Project: Retail Tenancy 5 – Overseas Passenger Terminal

Report: BCA & Access Assessment Report

Reference No: 107134-BCA-r3

Date: 10 October 2016

Figure 28 in AS1428.1-2009

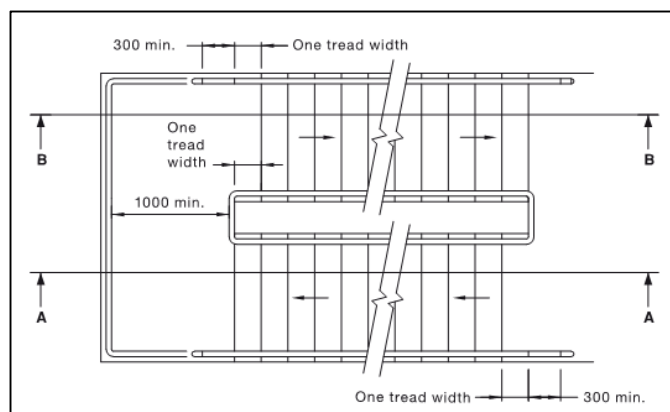
- Handrails at the top and bottom of the new stairways are to have the 300 mm horizontal extensions, plus downturn, as per AS 1428.1-2009. No handrail extensions are currently indicated at the top of egress stair 2.
- Egress Stair 1 is not provided with a 1 tread off-set at the base of the top flight at the mid-landing, to provide for compliant handrails with no vertical sections, as per Figure 28 of AS 1428.1 below. The handrail shall follow the angle of the nosings and be consistent height through the stair flight and any landings with no vertical sections at the landing. Compliance can be achieved via offset risers at the bottom of the flight in accordance with Figure 28 in AS1428.1-2009 or with larger landings to accommodate required handrail extensions.

Figure 28 in AS1428.1-2009

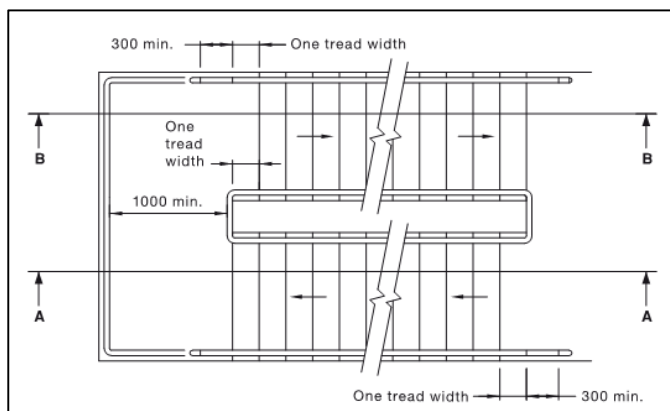
The handrail shall follow the angle of the nosings and be consistent height through the stair flight and any landings with no vertical sections at the landing. Compliance can be achieved via offset risers at the bottom of the flight in accordance with Figure 28 in AS1428.1-2009 or with larger landings to accommodate required handrail extensions.
